## GIG HARBOR FIRE AND MEDIC ONE

### GIG HARBOR STATION 51

#### ADDENDUM #01

September 5, 2025

ENLARGED  
REFLECTED CEILING  
PLANS

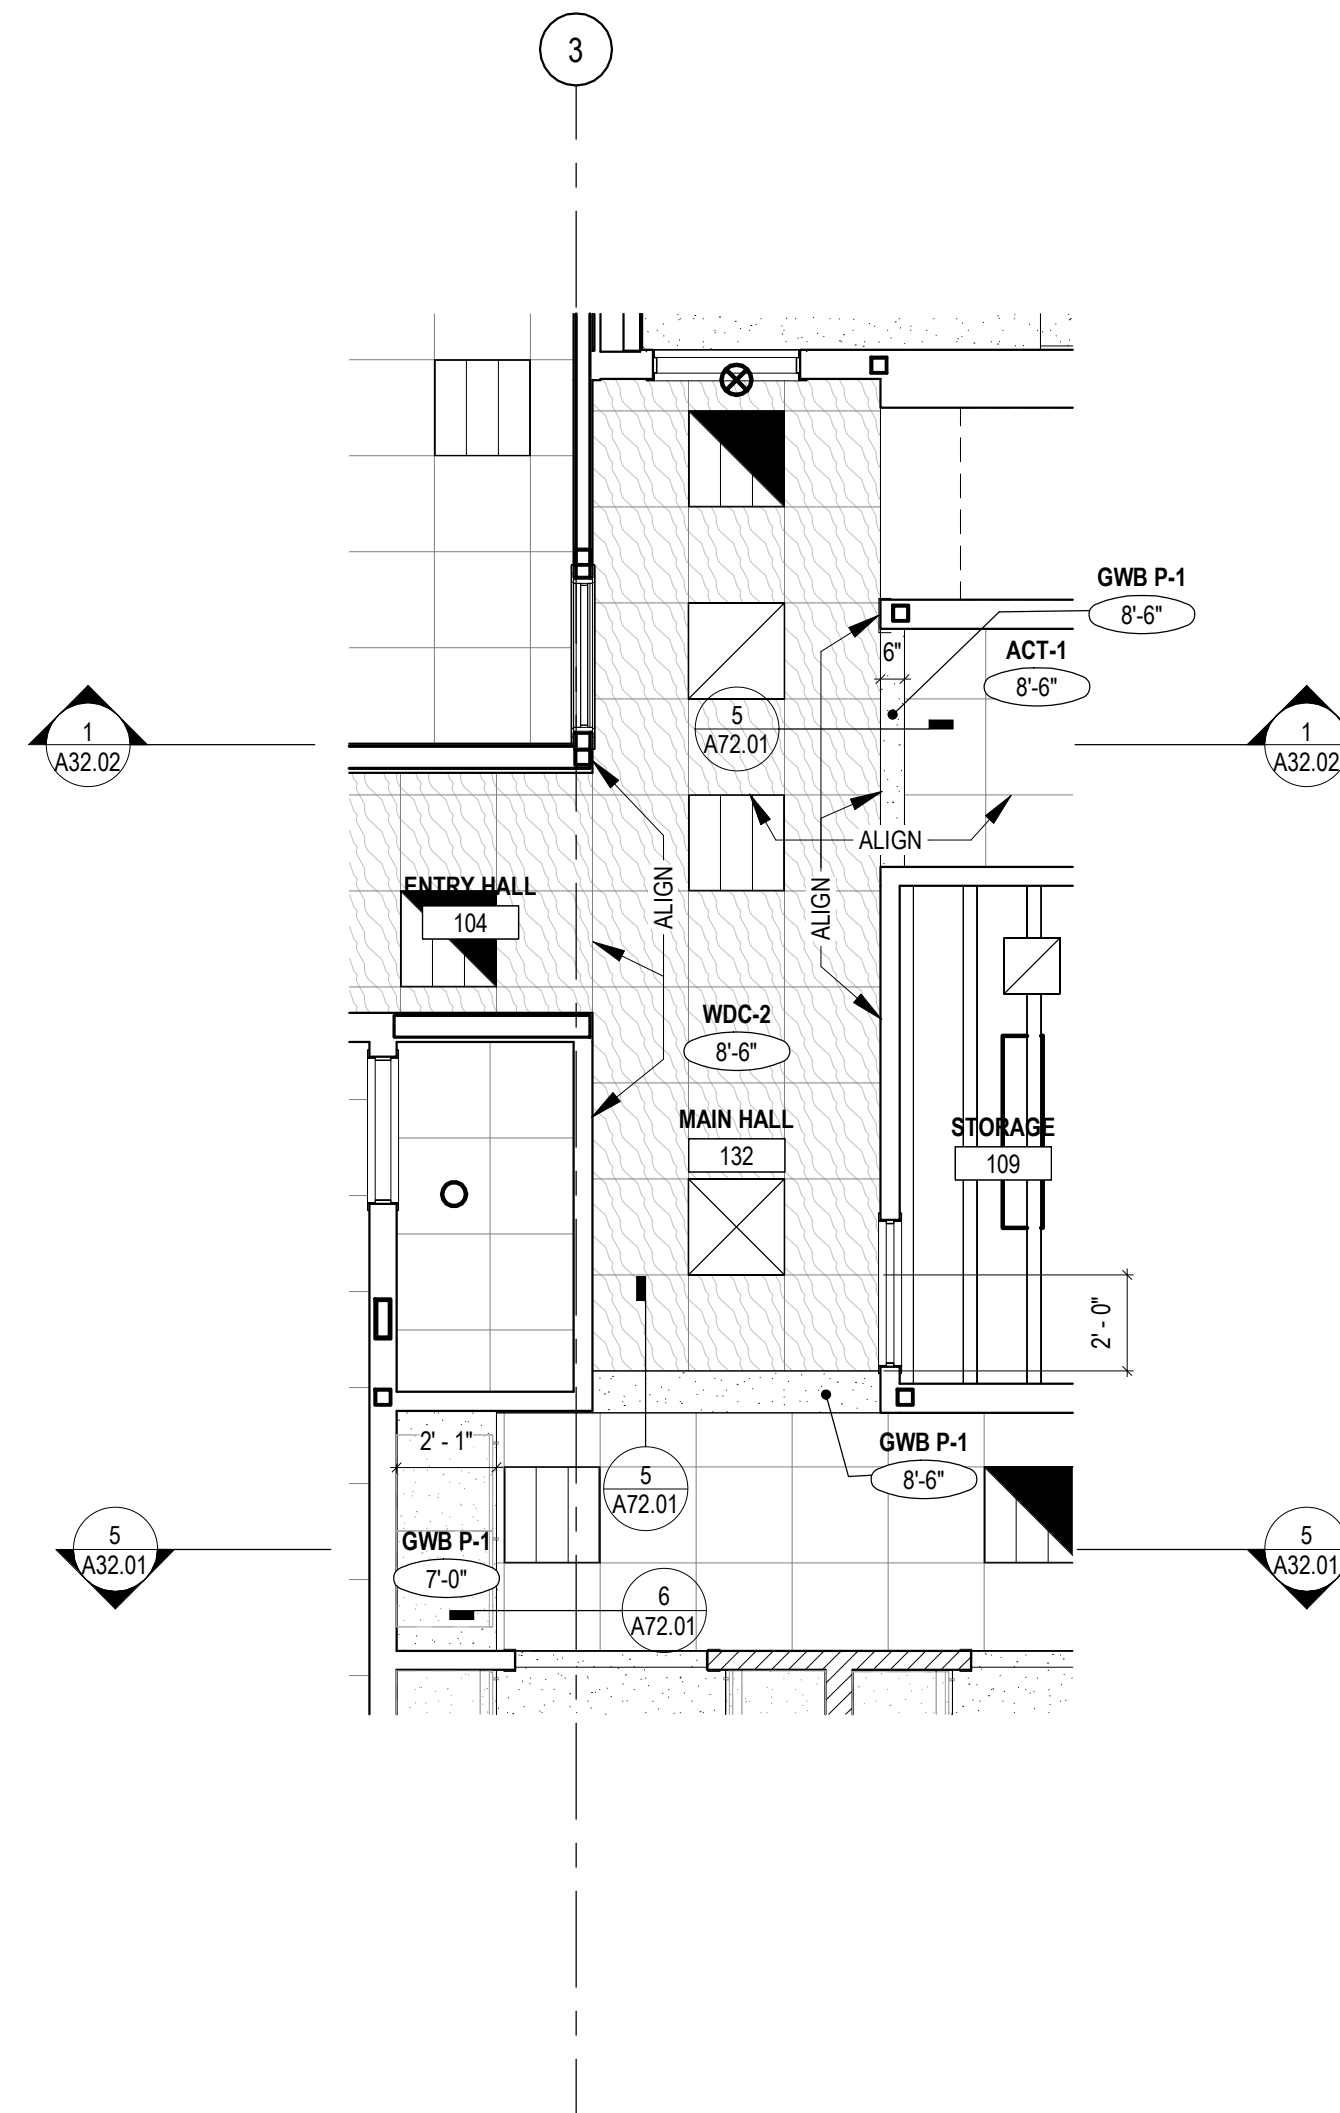
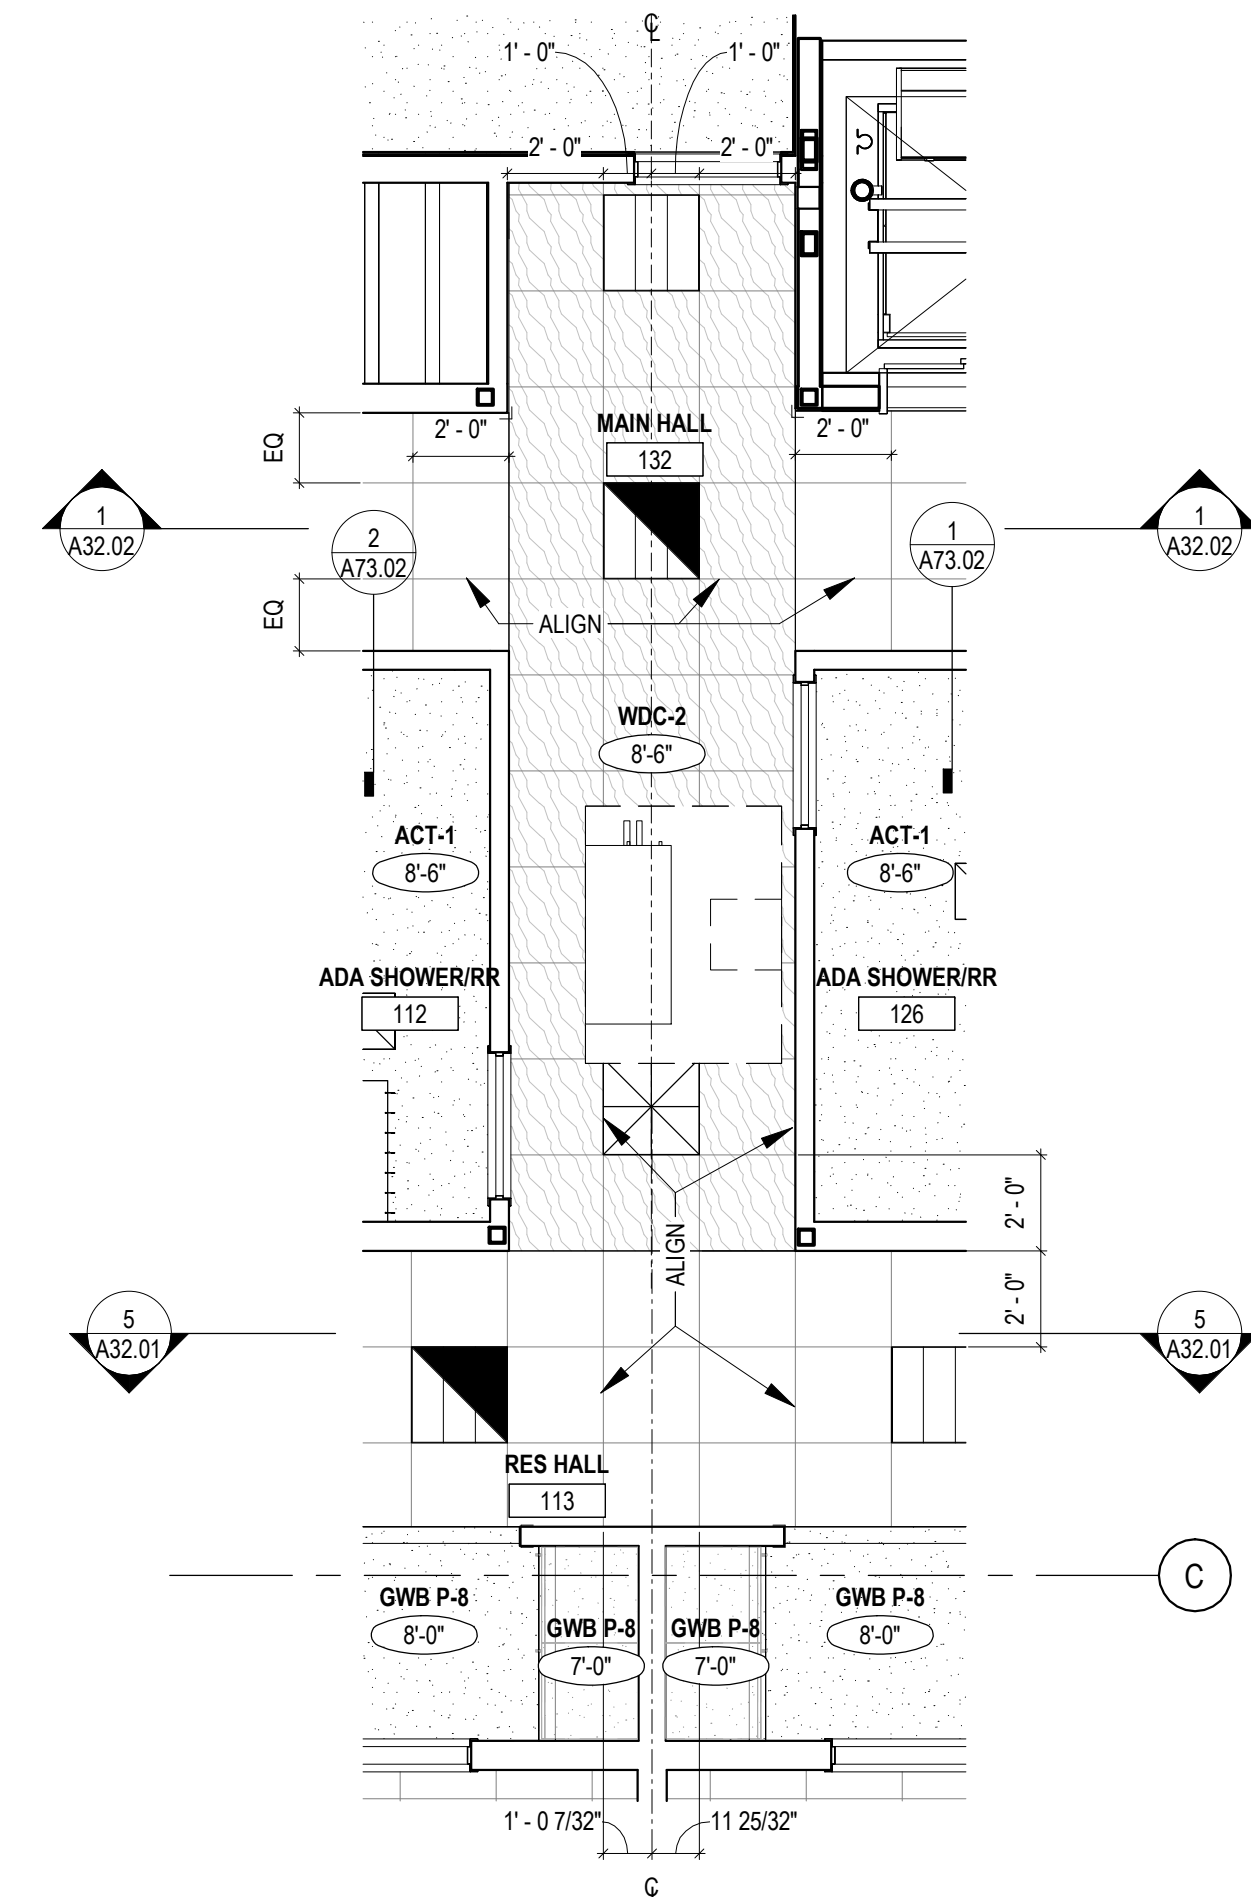
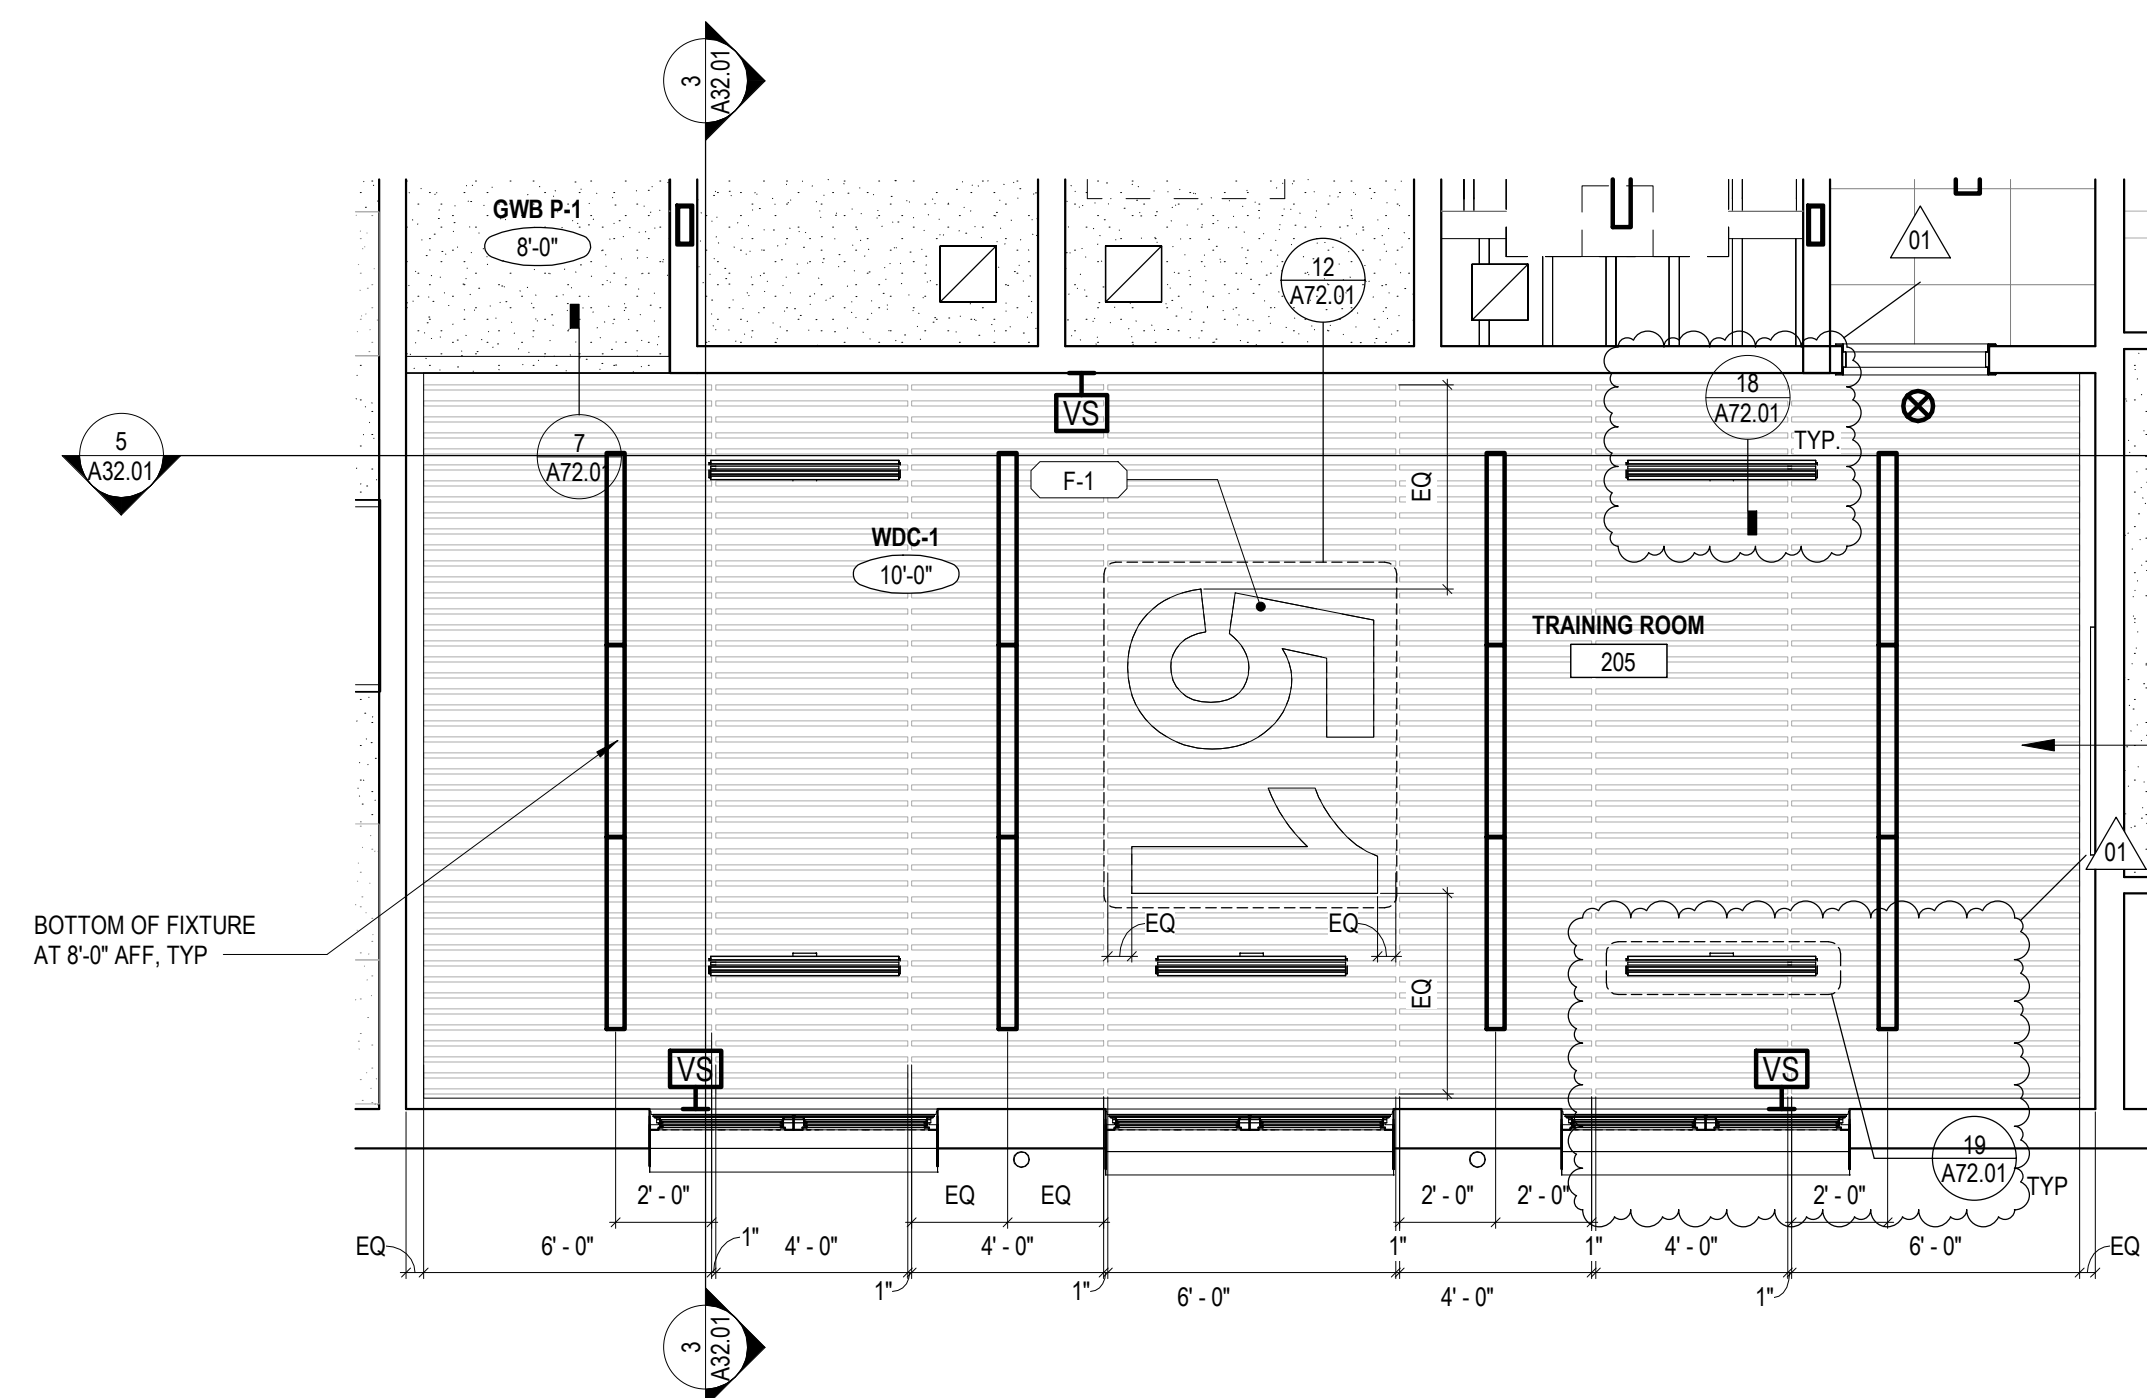
- ITEM 6** A00.01 – PROJECT INFORMATION, VICINITY MAP, PROJECT DESIGN TEAM: Revise "PROJECT DESIGN TEAM, ELECTRICAL ENGINEER" to "CHUCK HEATON, [caheaton@gftinc.com](mailto:caheaton@gftinc.com)," and "OLEG CHEROV, [okcherov@gftin.com](mailto:okcherov@gftin.com)." Note, phone number remains as listed.
- ITEM 7** C0.00 – COVER SHEET: **Added** sheet C03.03 to sheet index, **revision** to instructions for pre-construction meeting, revision to legend, and **revision** to site plan (see attached).
- ITEM 8** L01.00 – PLANTING PLAN: **Revision** to plant layout at NW and SE corners, revisions to notation along frontage (see attached).
- ITEM 9** L03.00 – IRRIGATION PLAN: **Revision** to irrigation layout at NW corner (see attached).
- ITEM 10** A28.01 – ENLARGED REFLECTED CEILING PLANS
